| Project Title: | Redondo Beach Energy Project |
| Document Title: | City of Redondo Beach - Preliminary Staff Assessment Workshop - Community Noise Issues |

Redondo Beach Energy Project Preliminary Staff Assessment Workshop

Community Noise Issues

1D: Tonal Noise and dBA

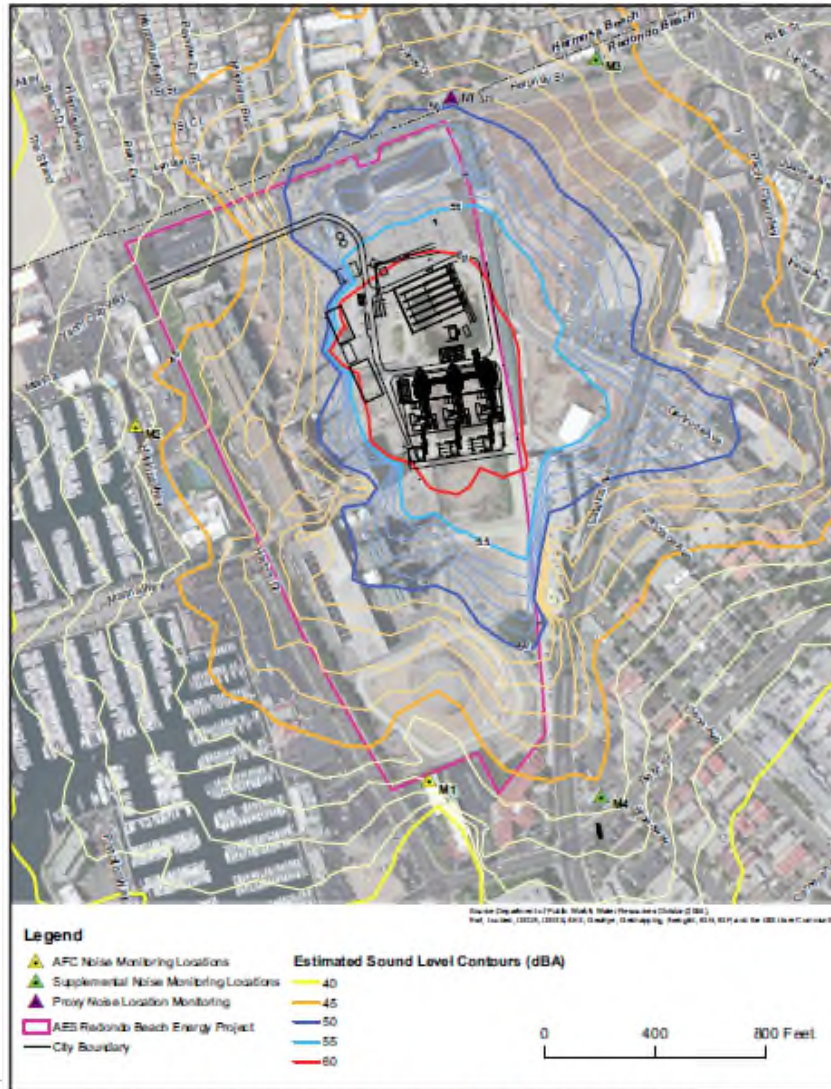
- The noise spectrum of existing power plant noise was not measured.
- Potential tonal noise was not calculated.

- One-third octave band noise levels should be measured to determine if tonal noise is currently a source of complaints.
- Expected tonal noise should be studied, by calculation or by measurements of a similar facility.
